RE: DRAINAGE PLAN FOR 13812 WINTERWOOD WAY (L-23/D2A)

RE: DRAINAGE PLAN FOR 13812 WINTERWOOD WAY, SE

DRAINAGE REPORT

13812 WINTERWOOD WAY

EXHIBIT "E"

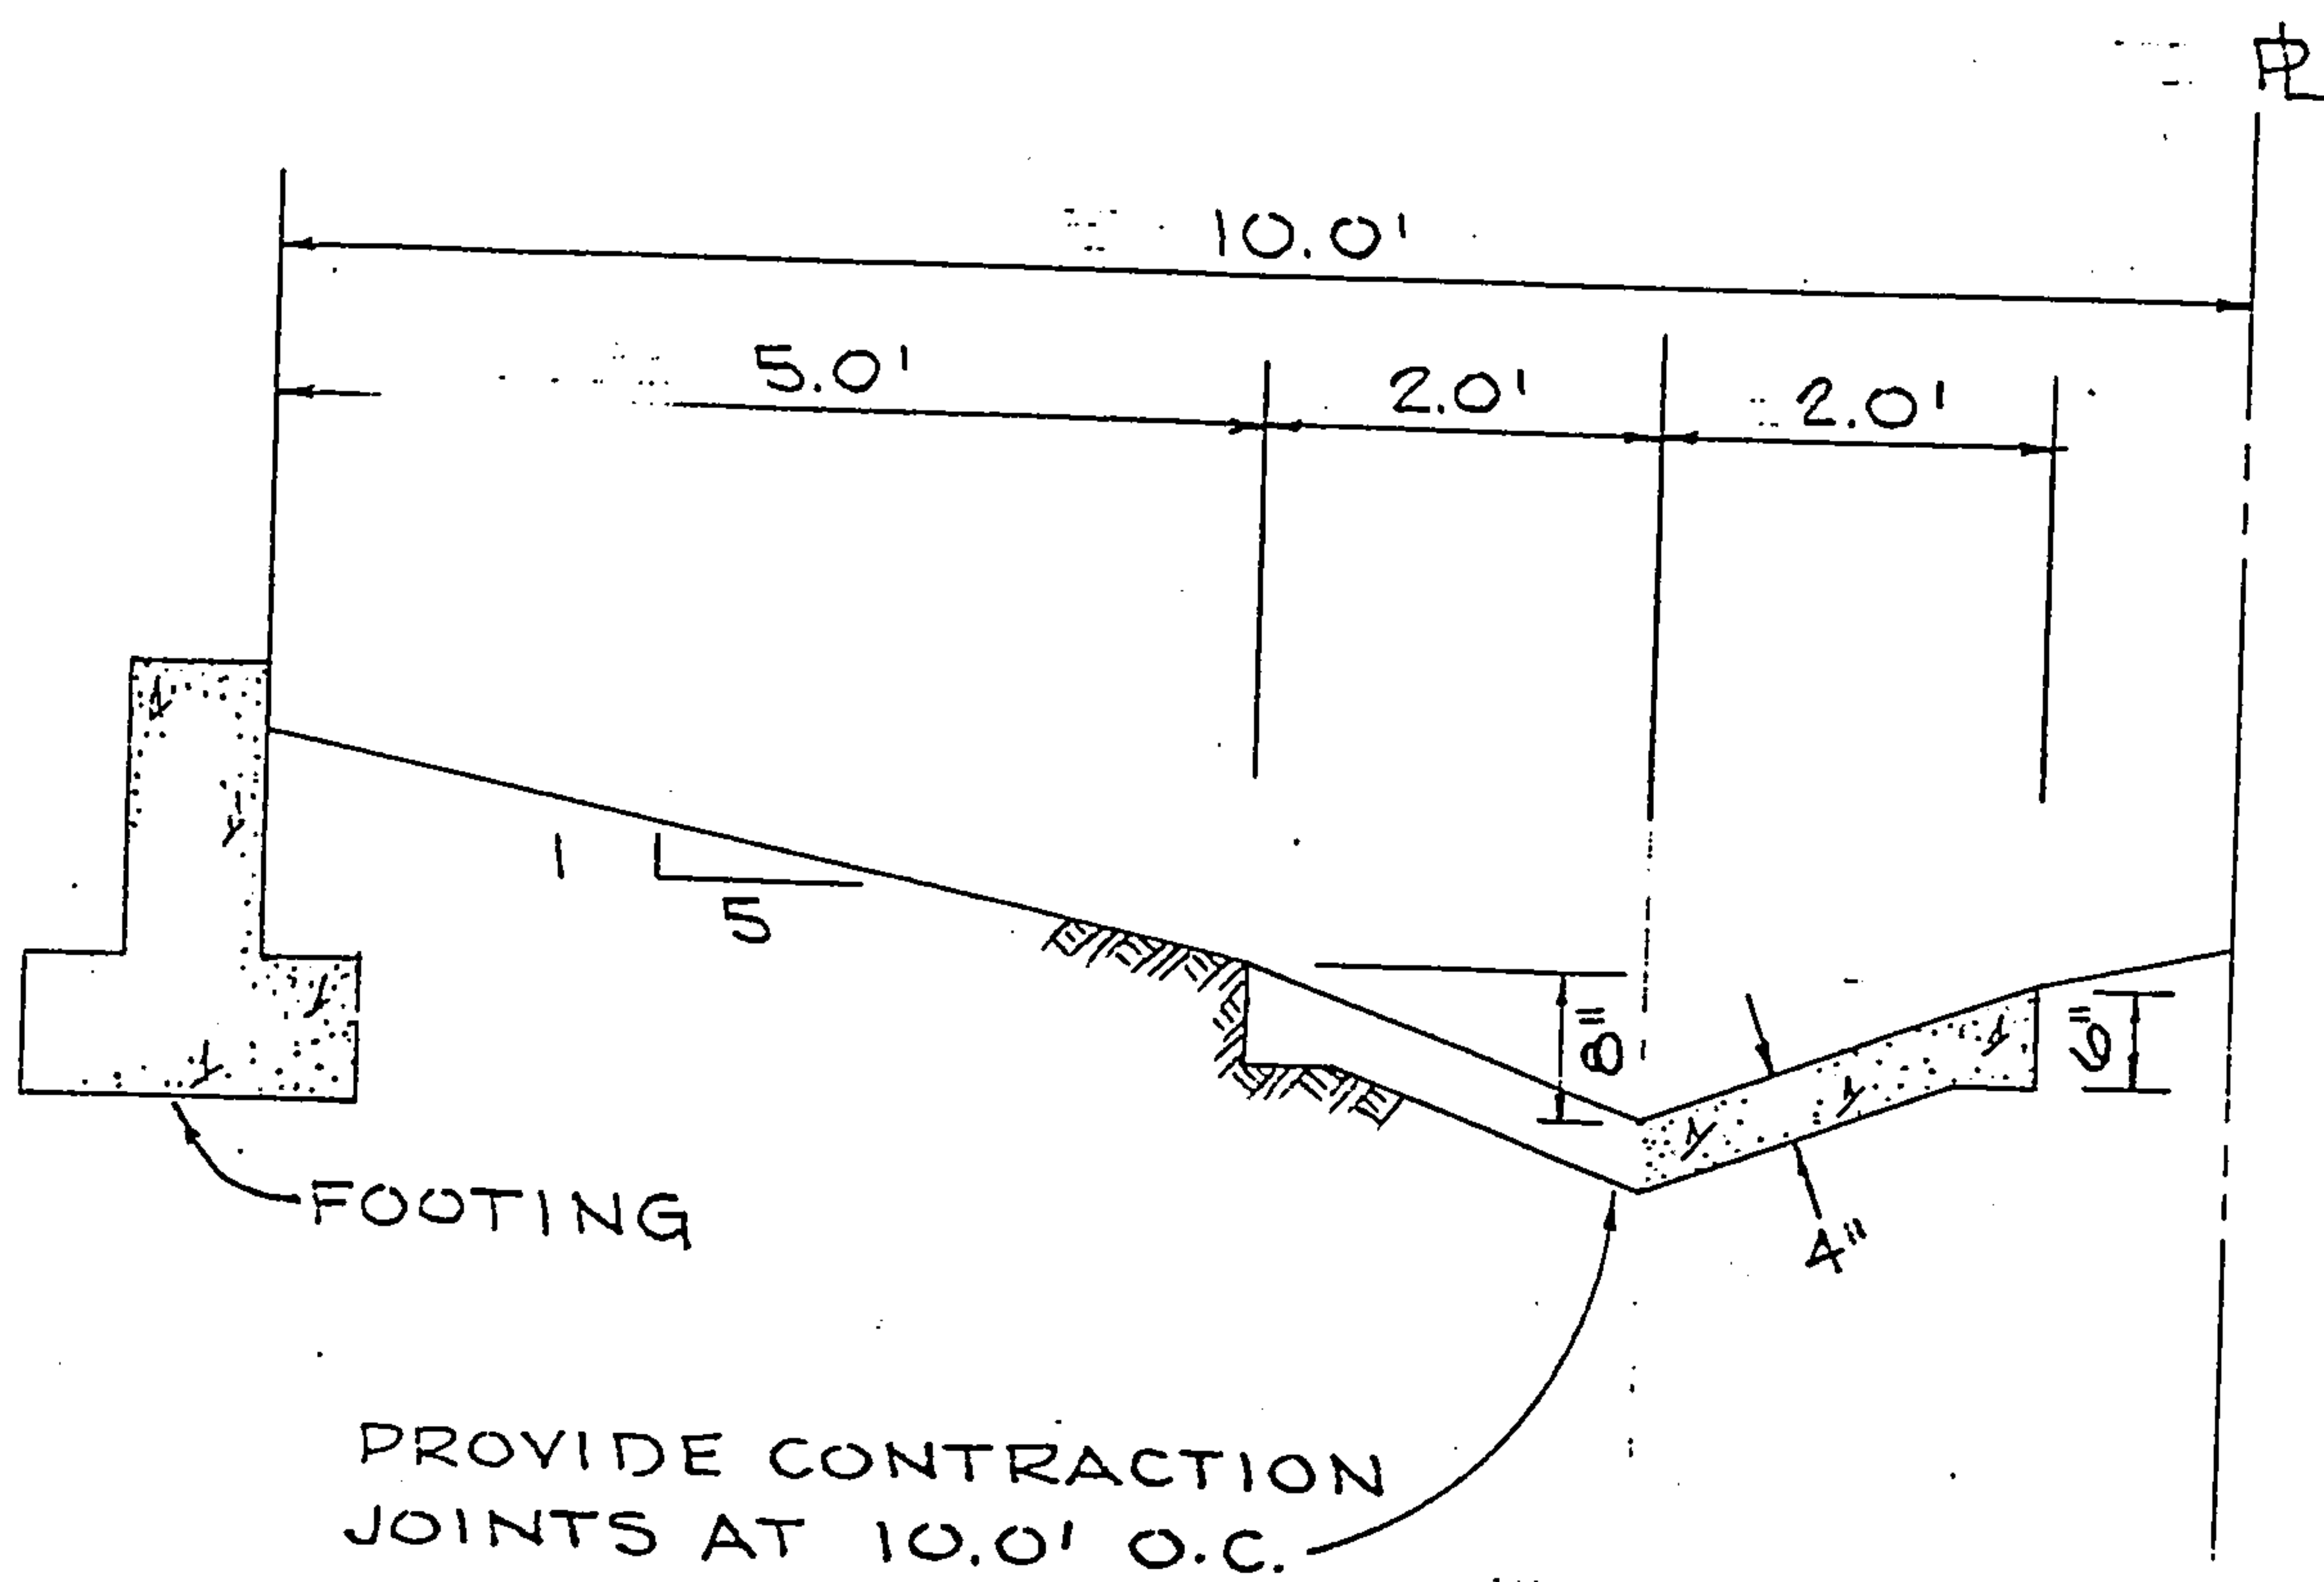
A field visit to the referenced site has been conducted, and it has been determined that the concrete channel was not constructed as shown on your engineer's design. A copy of this design (Exhibit "E") is attached for you to follow in the reconstruction of the channel.
